Minor Variance Application

A105/21

Property: **83 Camden Dr Woodbridge**

Purpose: Relief from By-law 1-88, as amended, is being requested to permit the construction of a proposed sunroom addition located at the rear of the existing dwelling.

SITE PLAN

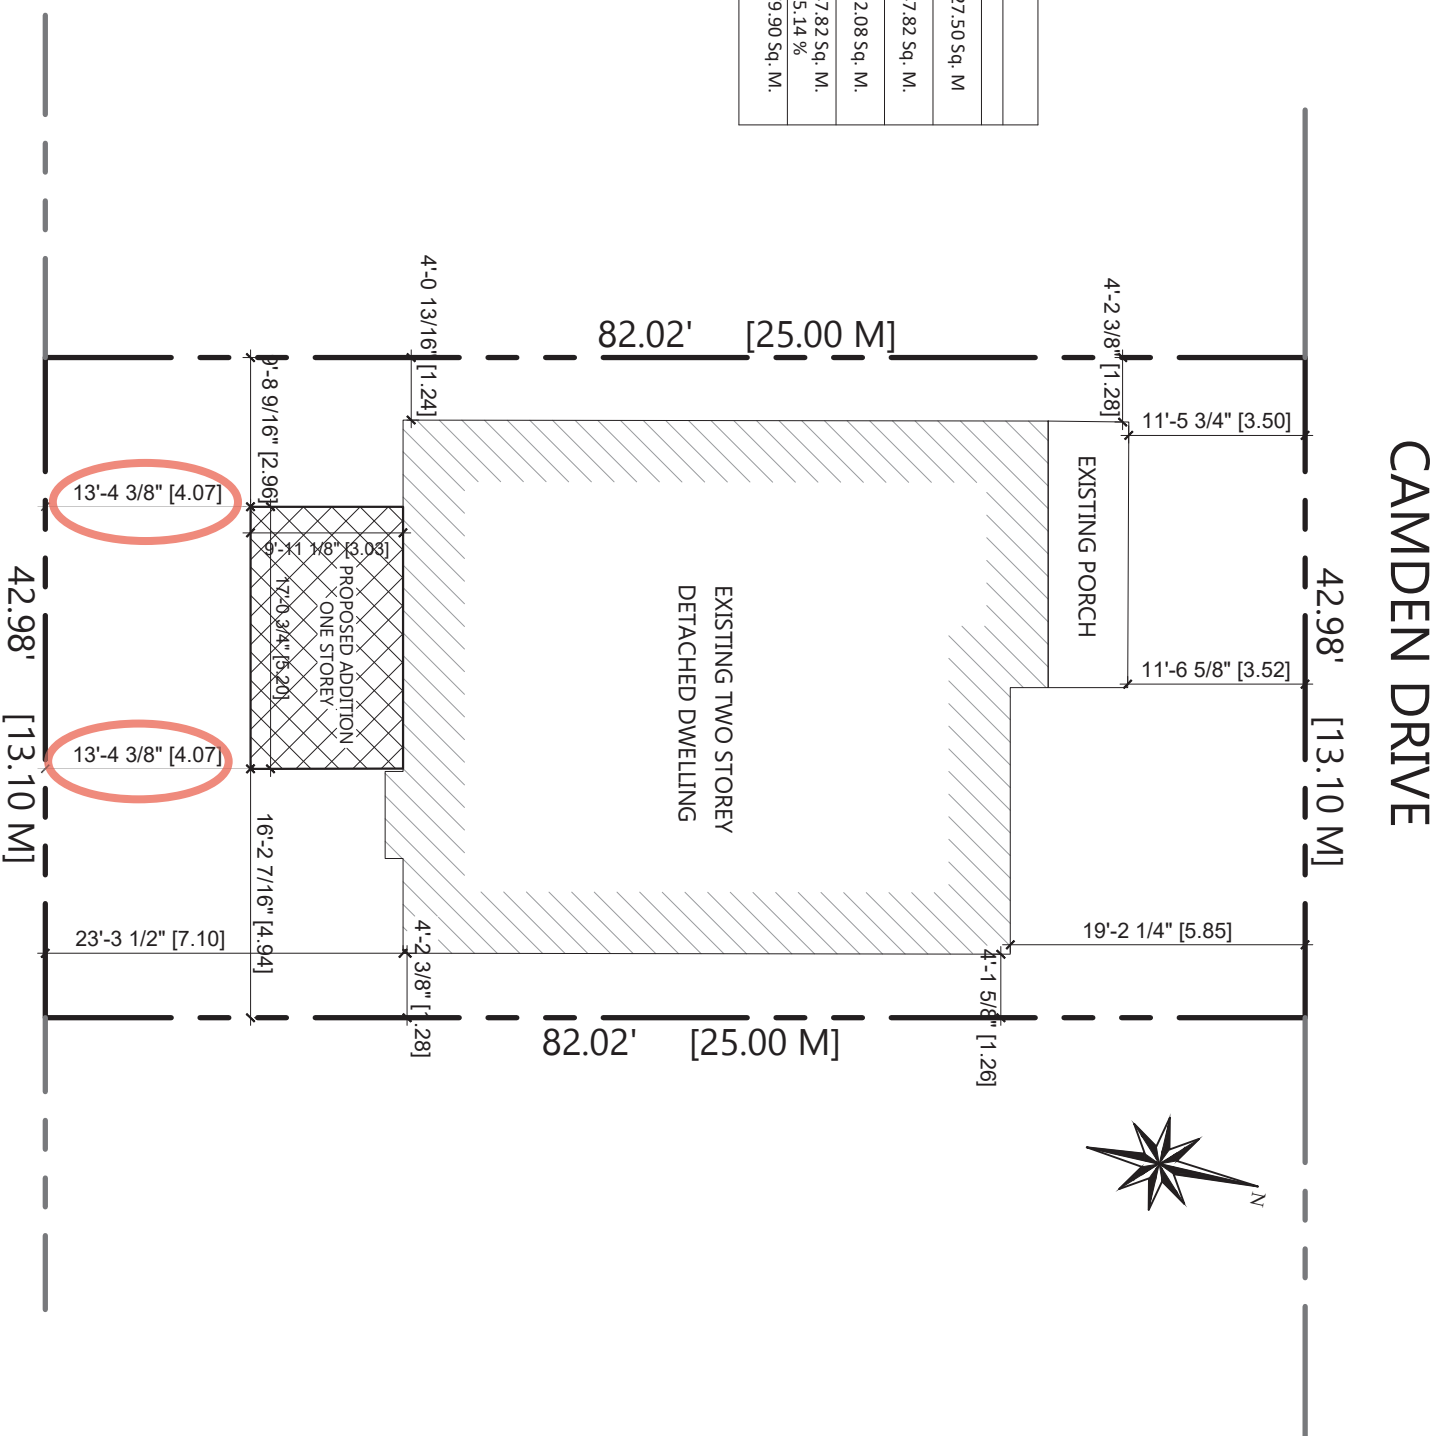
By-law Requirement	Proposal
A minimum rear yard setback of 6.0m is required. (Schedule T.113)	To permit a minimum rear yard setback of 4.07m .

In response to Development Planning, the applicant increased the proposed rear yard setback from 3.77m to 4.07m. Variance has been confirmed by zoning staff.

The Owner is requesting permission to construct a single-storey sunroom addition in the rear yard. Development Planning staff worked with the Owners to revise their proposal to increase the rear yard setback from 3.77 m to 4.07 m to ensure the proposal remains compatible and consistent to other rear yard amenity areas.

The Development Planning Department is of the opinion the proposal is minor in nature, maintains the general intent and purpose of the Official Plan and Zoning By-law, and is desirable for the appropriate development of the land.
